SB Number:	SB 2C9-005	Creation Date: 02/04/2004
Subject:	Starter toner quantity change	
Model:	KM-1620

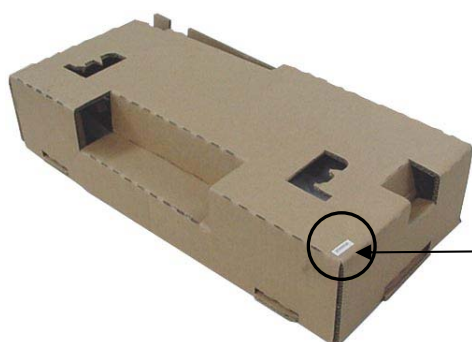
Please be informed that the quantity of starter toner supplied with the KM-1620 has been changed as follows.

OLD	NEW
<i>Quantity (in grams)</i>	290 g.	425 g.
<i>Expected lifetime (A4, 6% coverage)</i>	1,000 pages	3,000 pages

- ✓ The new starter toner is included as of below affected machine serial numbers and later.
- ✓ KM-2020 is supplied with the 3,000 pages starter toner from first mass production.
- ✓ A distinction can be made between the old quantity starter toner and the new quantity starter toner, supplied with the machine, by checking the label attached to the starter toner carton.

New quantity starter toner → * mark is added after the last digit: see example below.

OLD: 2C992530

NEW: 2C992530*

* is added.
